ADDENDUM NO. 1

July 28, 2022

Silver Creek High School Additions & Renovations
557 Renz Avenue
Sellersburg, IN 47172

This Addendum forms a part of and modifies the Bidding Requirements, Contract Forms, Contract Conditions, the Specifications and the Drawings dated July 8, 2022, by CSO Architects. Acknowledge receipt of the Addendum in the space provided on the Bid Form. Failure to do so may subject the Bidder to disqualification.

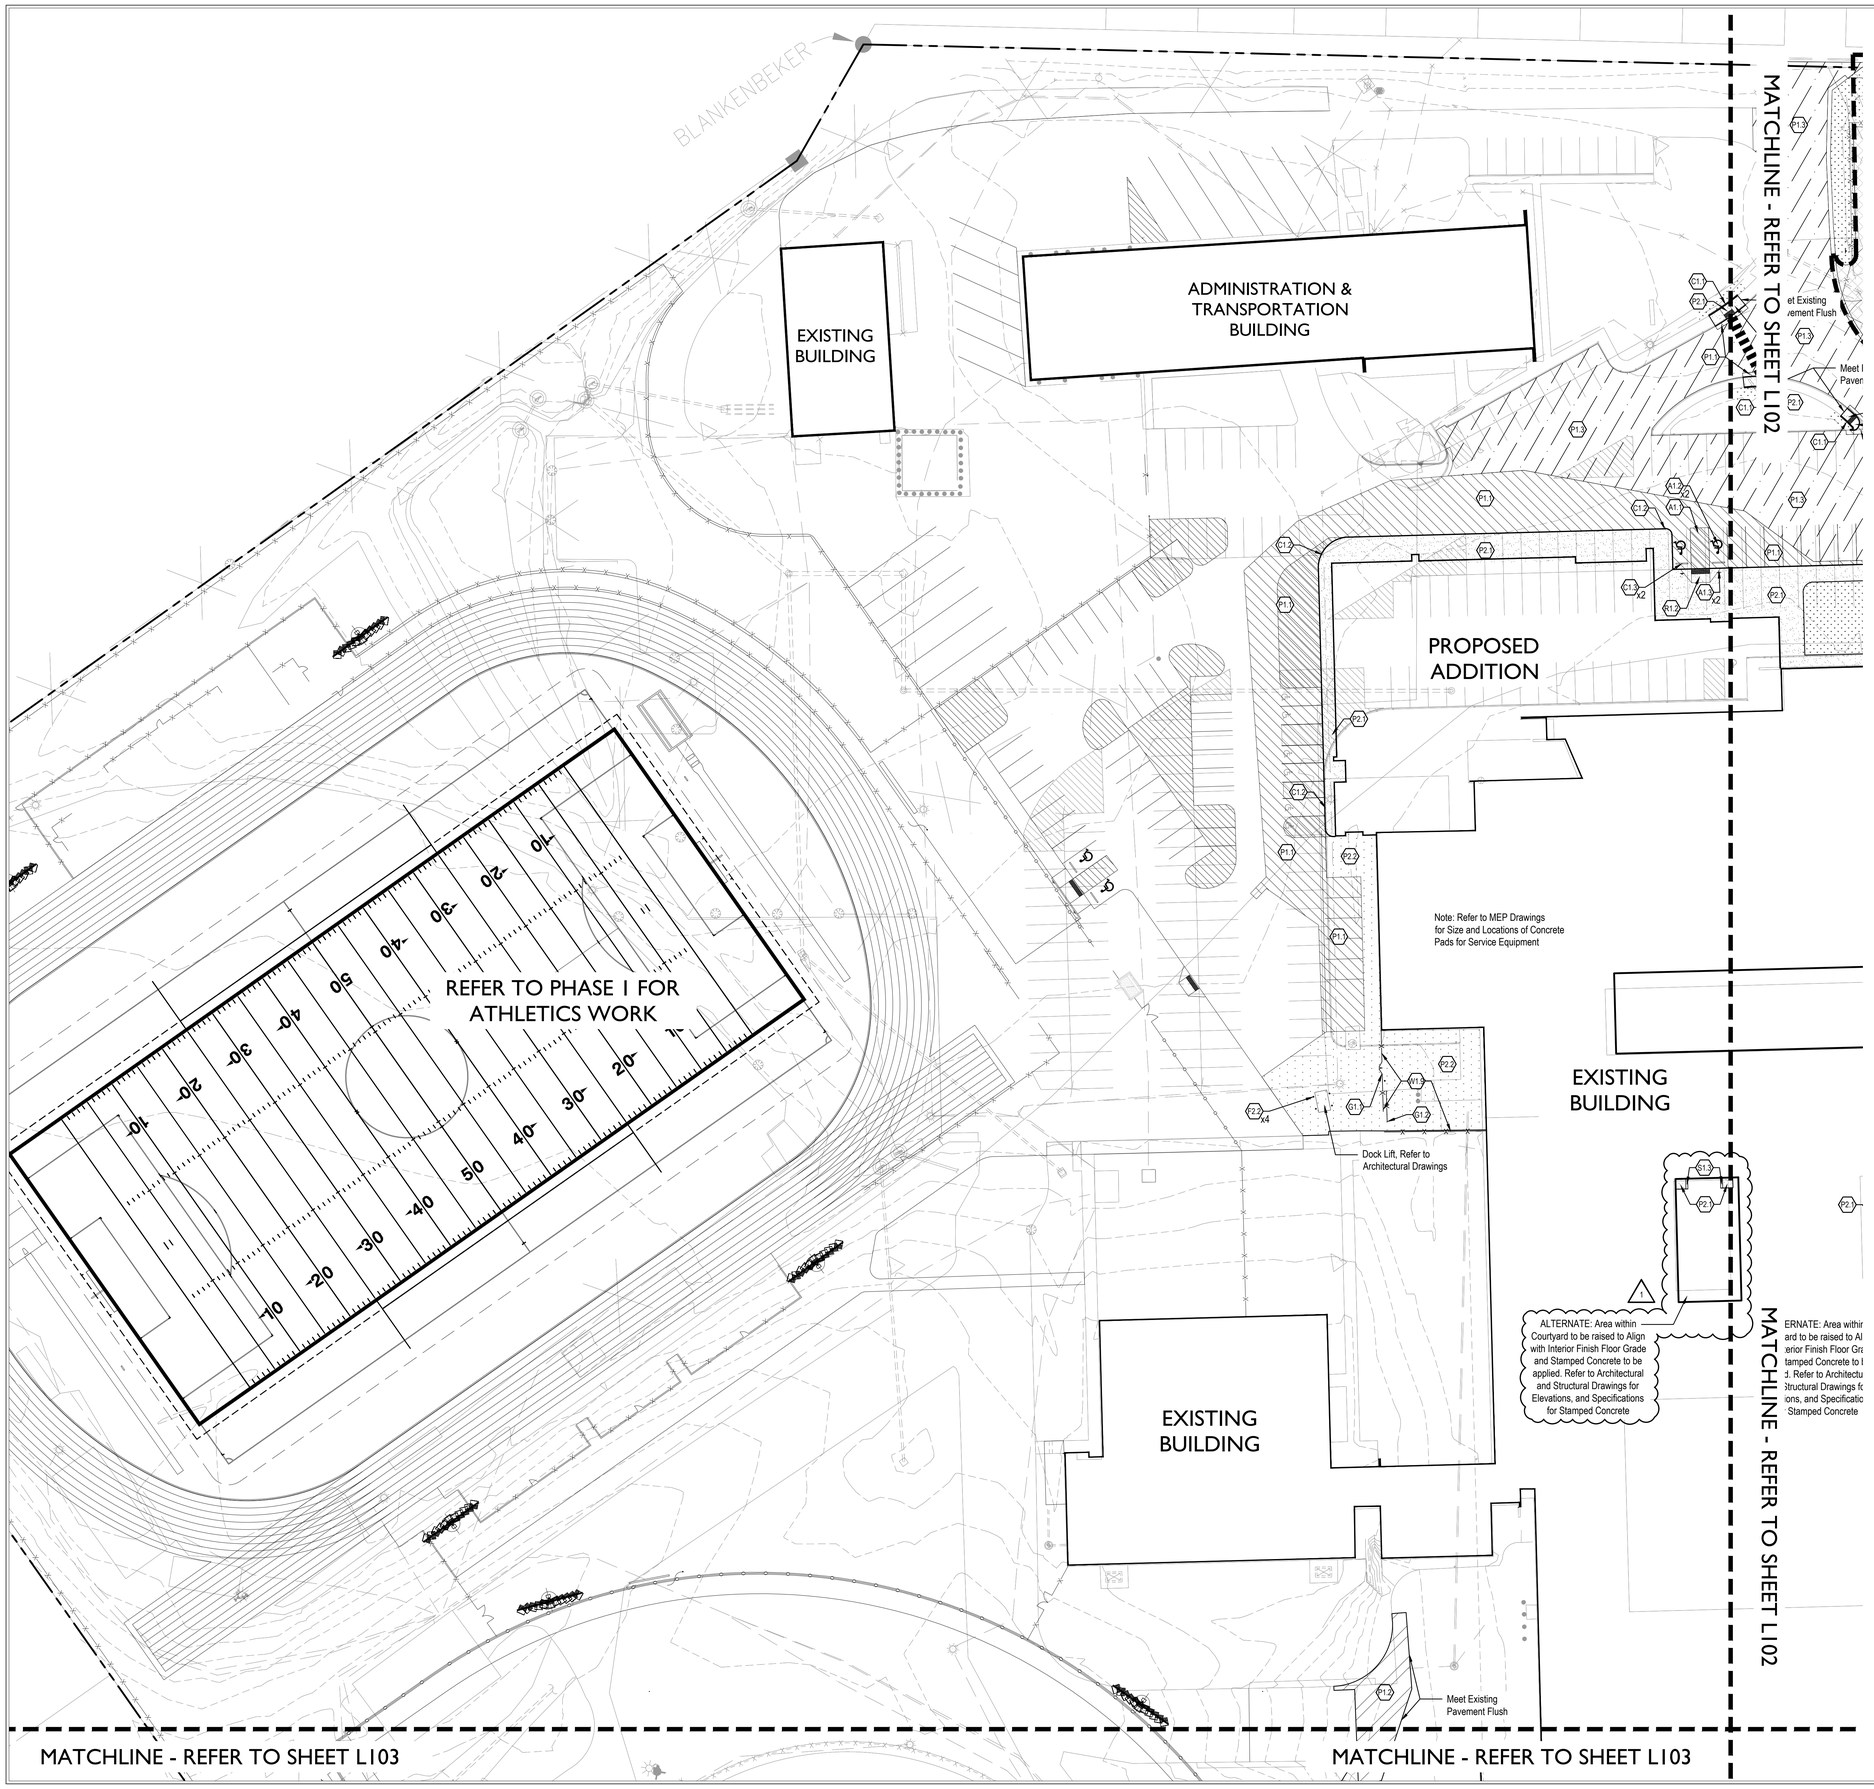
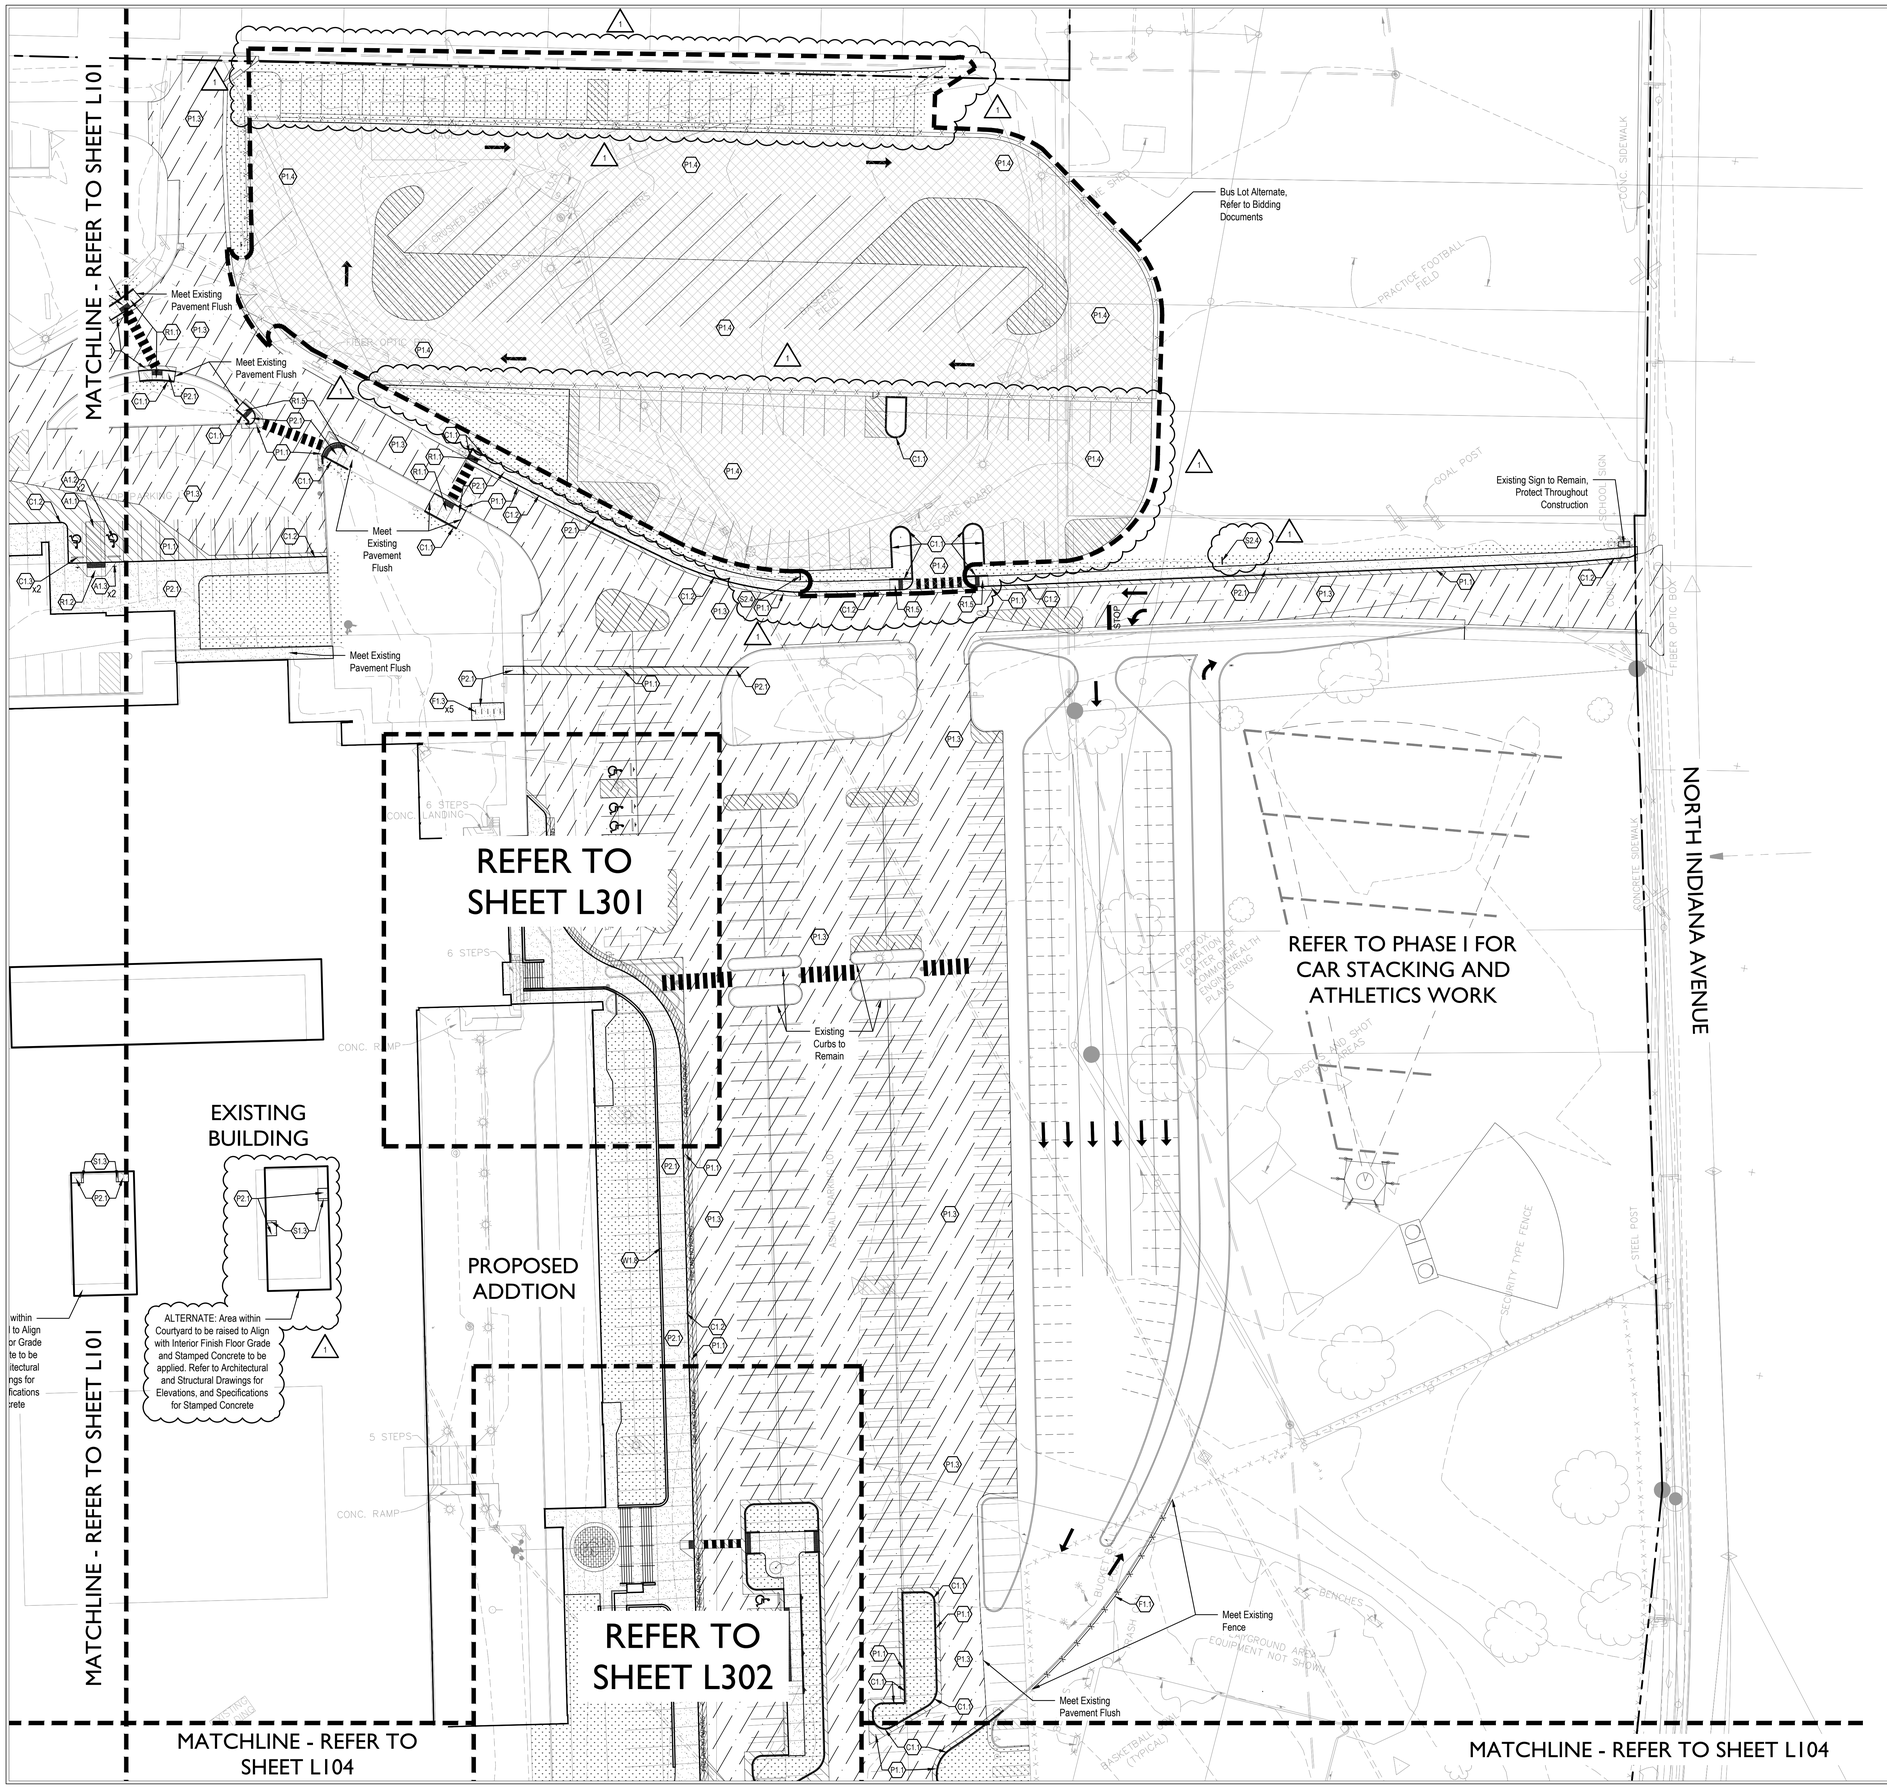
A. Detail 11/L502 COURTYARD CONCRETE PAD & RISERS added to Project.
